RE: **PresNow Uptown**  
**2100 Louisiana Blvd. NE**  
**Grading and Drainage Plan Stamp Date: 1/8/2021**  
**Drainage File: J19D055**

Based on the submittal received on 1/8/21 the above-referenced Grading and Drainage Plan is approved for Administrative Amendment.

DRAWING NAME  
**CONCEPTUAL GRADING PLAN**

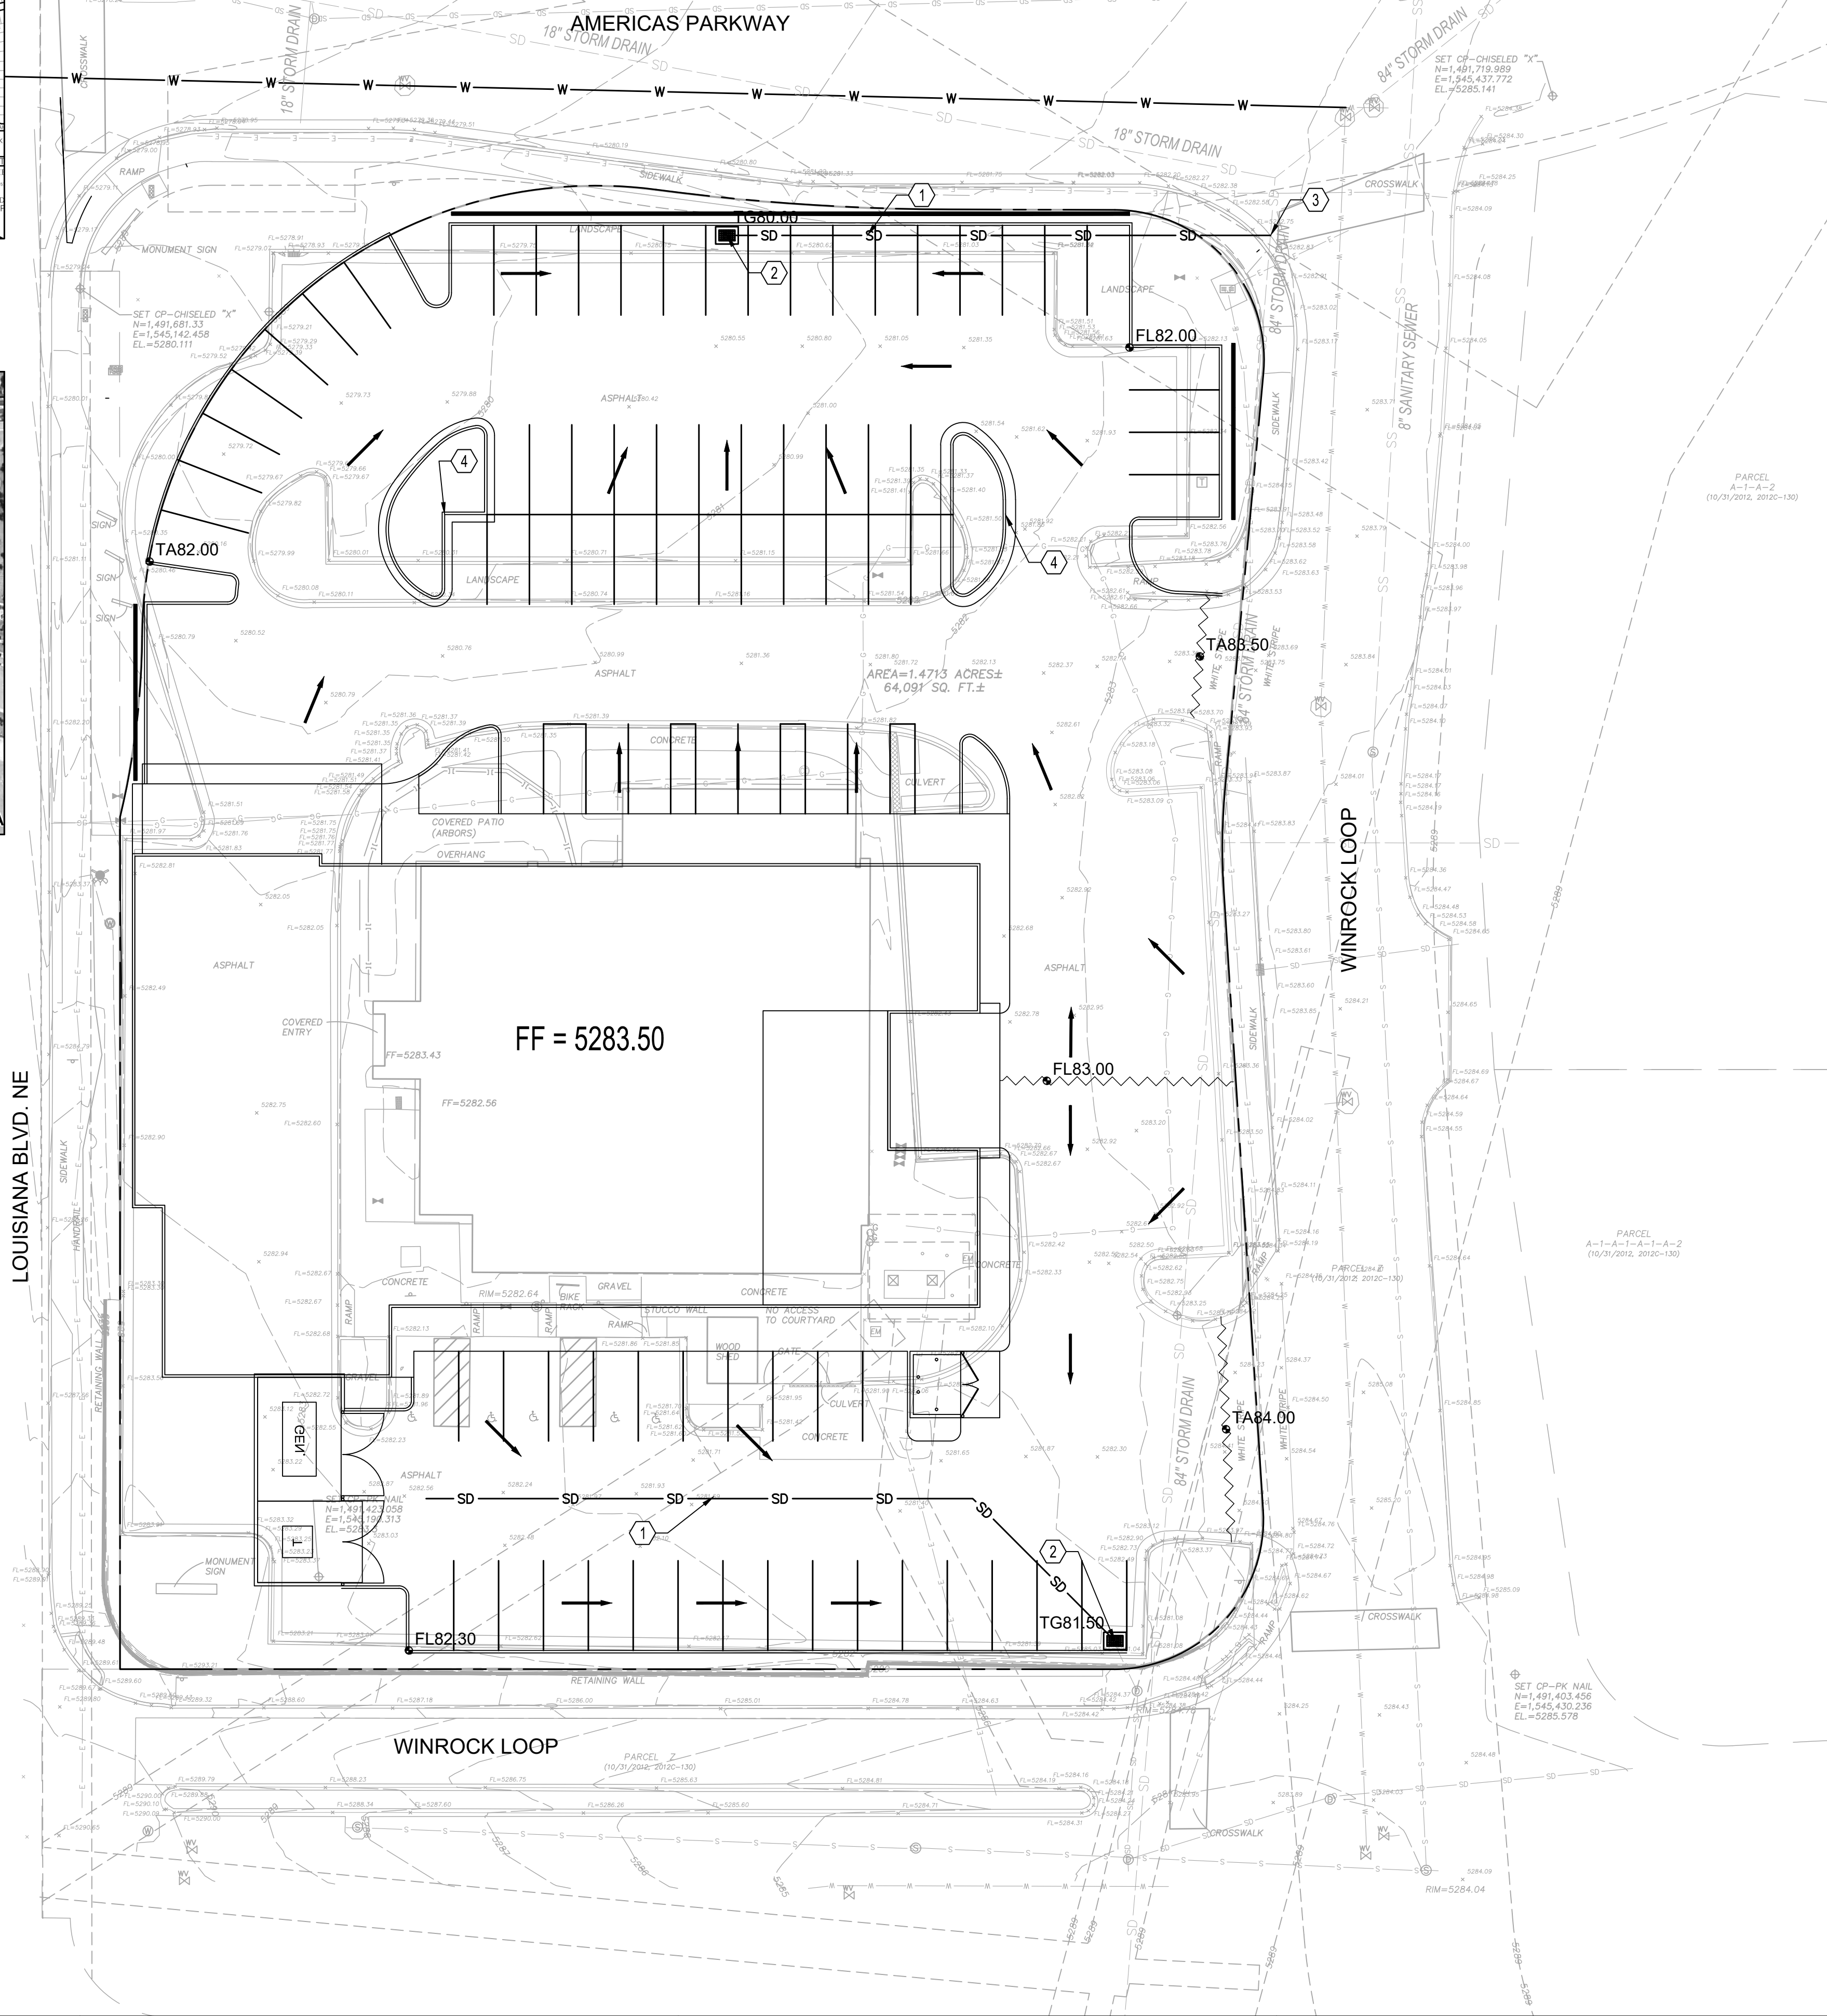
1. Please label and calculate separately the two drainage basins.
2. Show details and calculations for the new drainage inlets and new storm drain lines to show these will carry needed flows.
3. As a reminder, if the project total area of disturbance (including the staging area and any work within the adjacent Right-of-Way) is 1 acre or more, then an Erosion and Sediment Control (ESC) Plan and Owner's certified Notice of Intent (NOI) is required to be submitted to the Stormwater Quality Engineer (Doug Hughes, PE, [jhughes@cabq.gov](mailto:jhughes@cabq.gov), 924-3420) 14 days prior to any earth disturbance.
